PLAN
SHOWING PROPOSED BUILDING ON PLOT No 3A J.R. II
JERAI QUARTER
SCALE 8" = 1" HCH

KARACHI MUNICIPALITY.

With reference to your application dated 37.3.1932, with a plan for the proposed building/additions and alterations on plot No. 3A, Survey Sheet No. 8A.11, Loran quarter I have the honour to inform you that until the following requirements are complied with plans cannot be passed:—

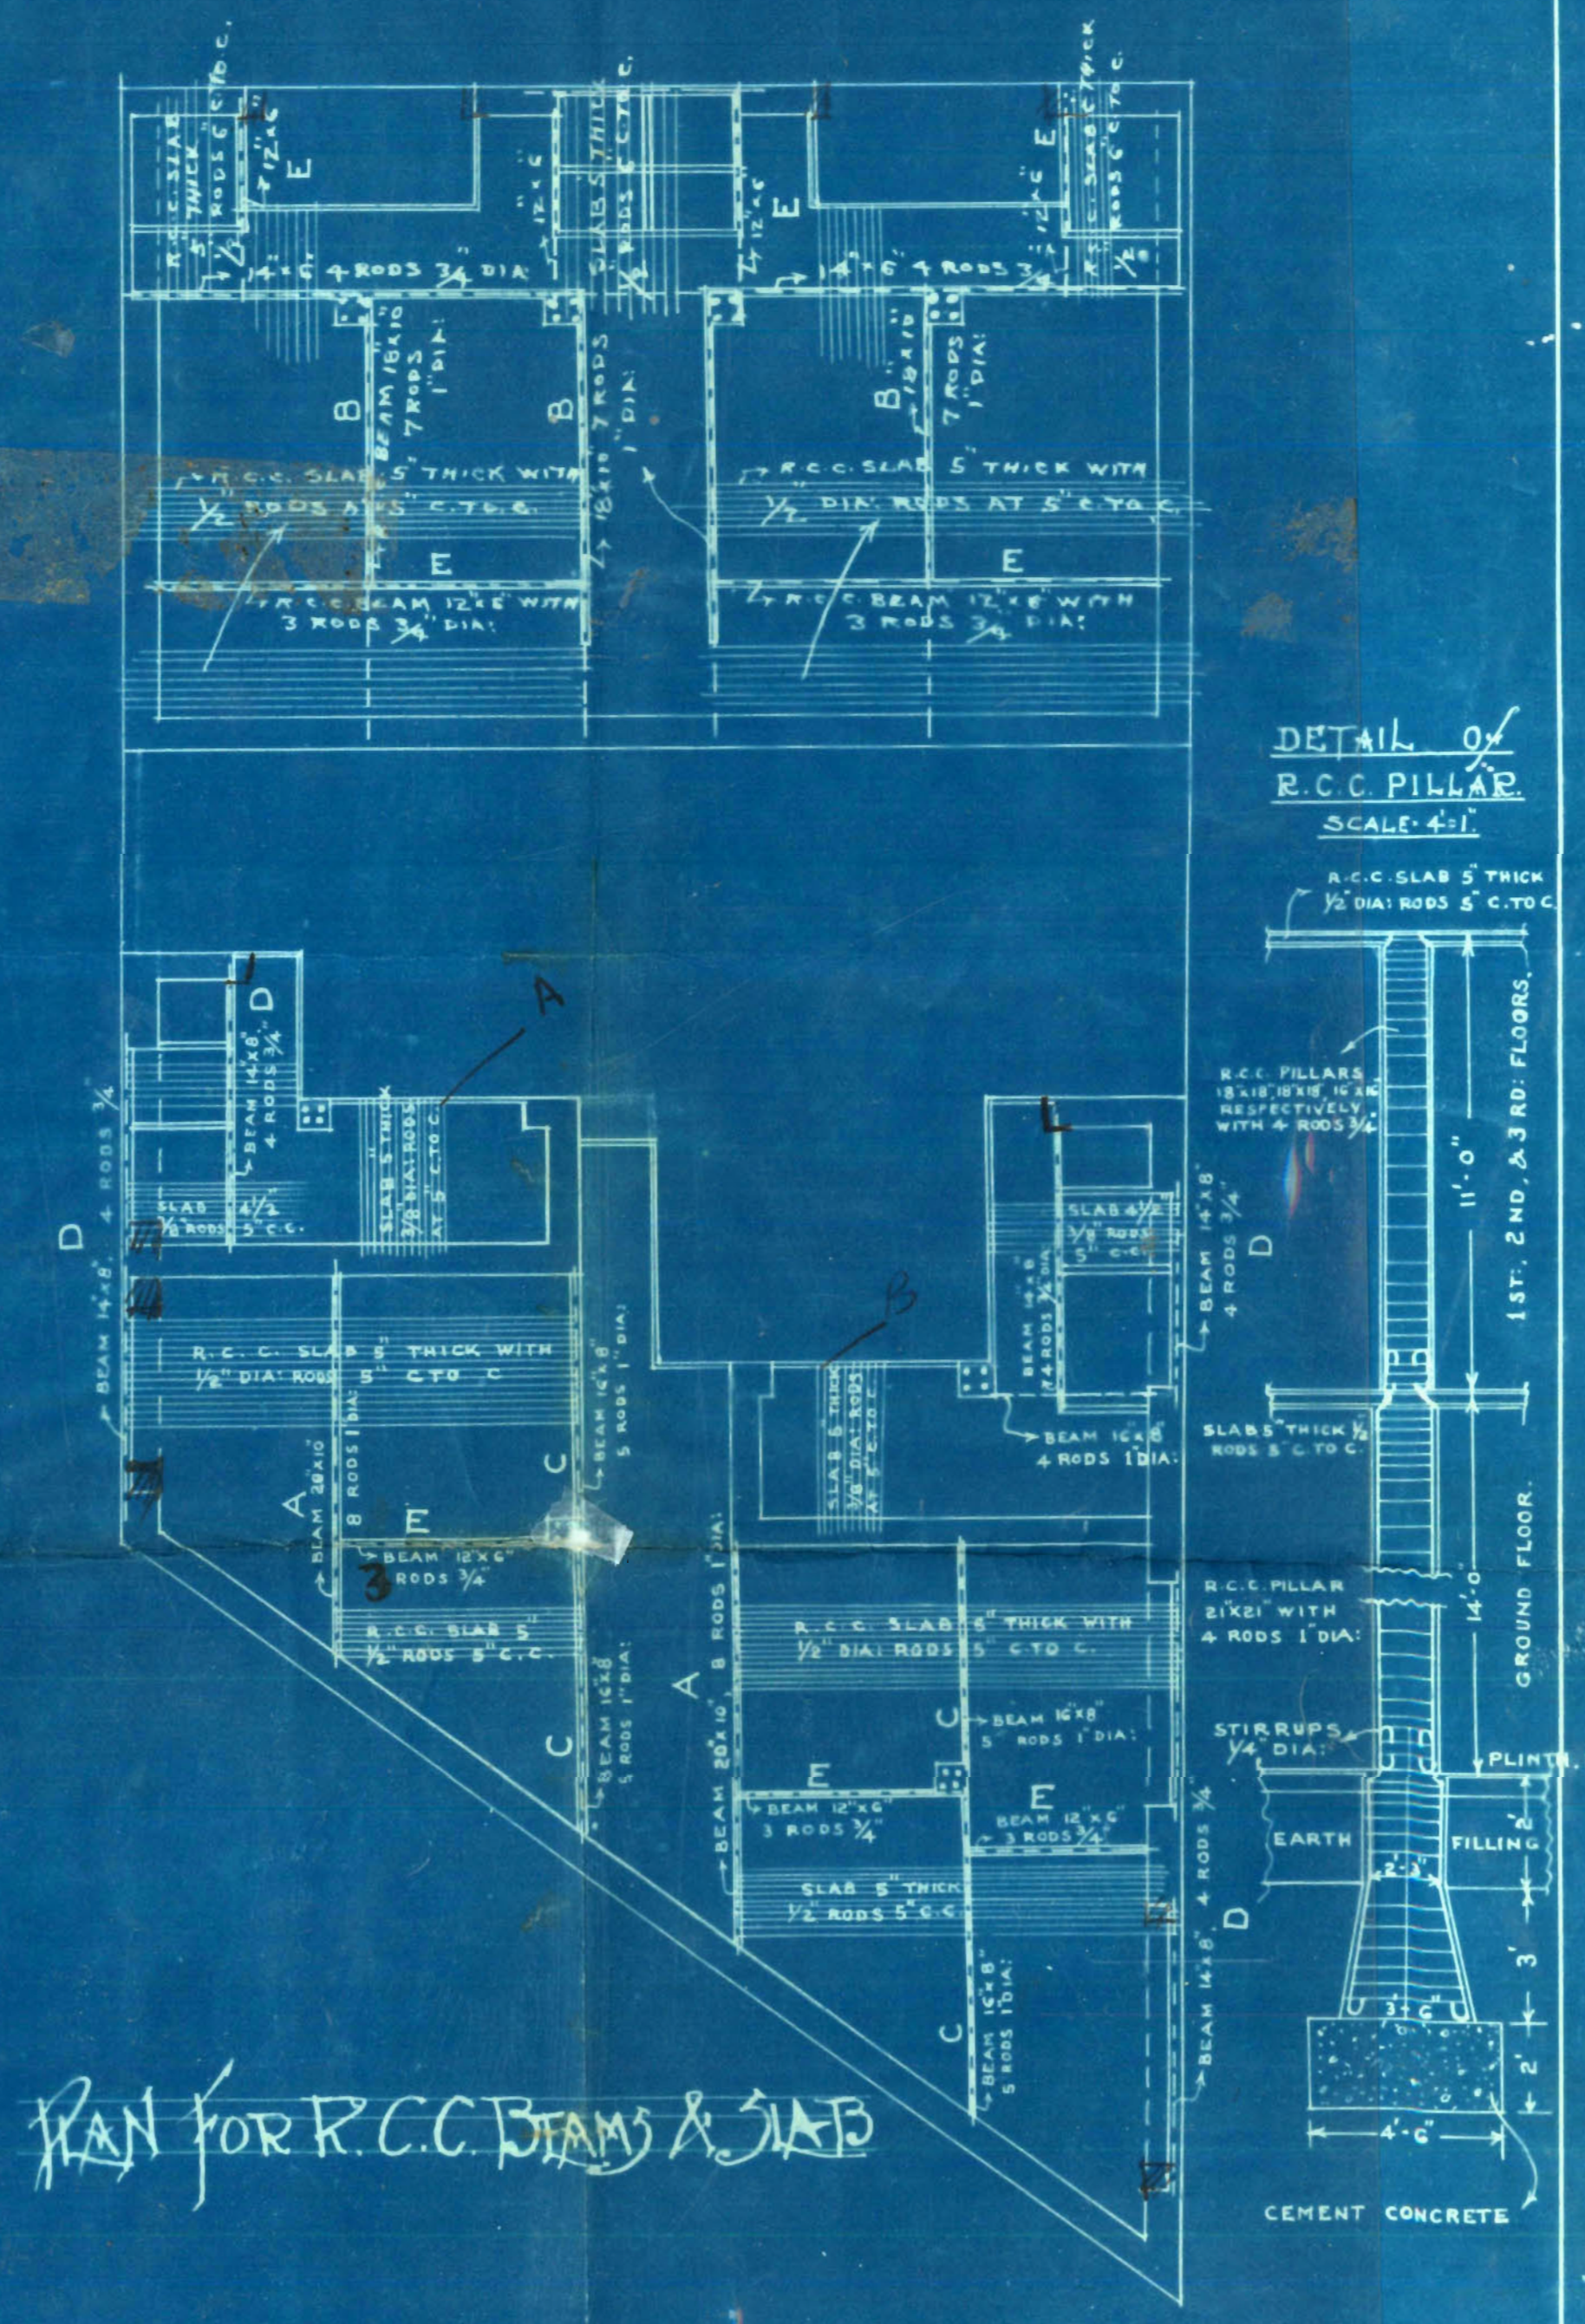
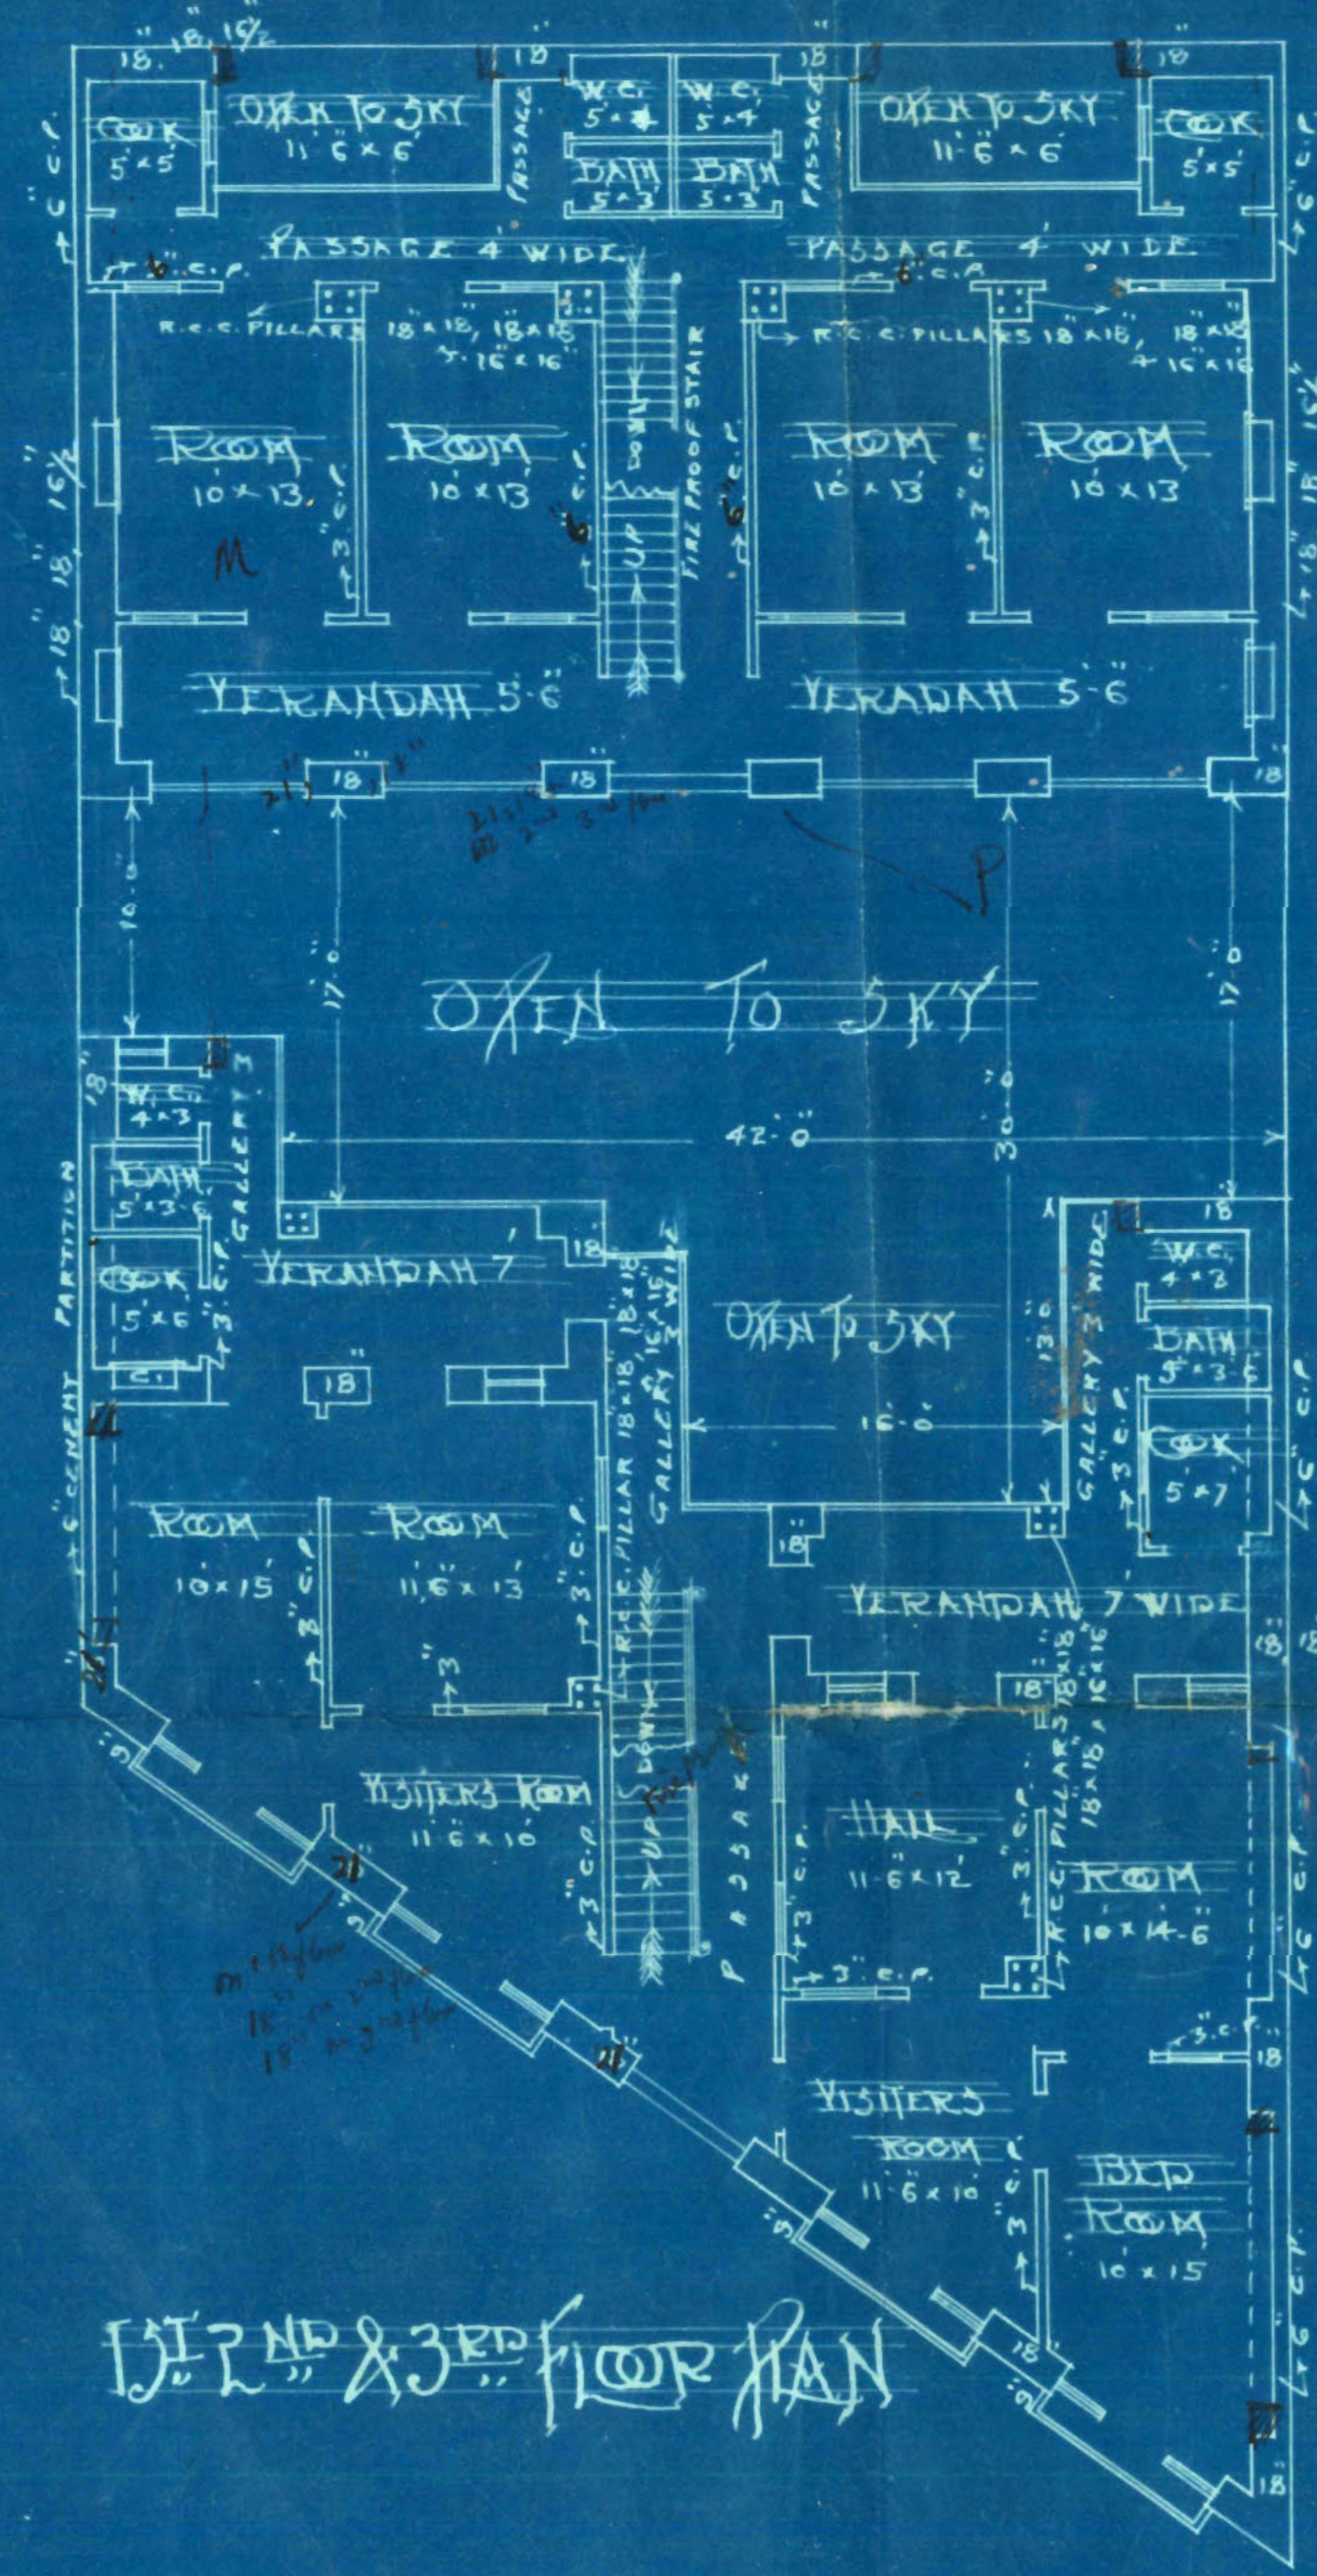
- (1) Size of front pillars must be increased & put down on plan.
- (2) Beams must be provided at A & B as marked in R.C.C. Plan.
- (3) Plans must be corrected as done in ink in the plan.
- (4) Both the stairs on all floors be fireproof
- (5) Front wall must be ~~23~~ $23\frac{1}{2}$ " 21 " $18\frac{1}{2}$ " & $18\frac{1}{2}$ "
- (6) Partitions along the stairs be 6" thick.
- (7) R.C.C. Columns must be 5' square at the base
- (8) Calculations for the load on pillars must be submitted clearly. They must be R.C.C.
- (9) Section must be corrected as shown in ink in the plan
- (10) Right of passage & easement on the N.W.R. Plot be produced
- (11) Room No. must have 6' open in front of it.
- (12) Central passage be taken 8' at the least.

With reference to your letter No: L.M.A.B.S.P. 156 dated 16/4/32 regarding plan of building on plot No: 3 A sheet S.R. 11 Serai Quarter we beg to return the plans duly amended.

With regard to your objection No: 10, we beg to point out that our client has got right of easement on the N.W.Ry plot for which correspondence is going on with the Ry: Executives. We have shown the existing openings in our client's wall on the Ry: plot and which can be verified by you.

Regarding your objection No: 11, the open space left by us is more than what is required throughout excepting in front of a little bit in the Northern corner which can be permitted by you.
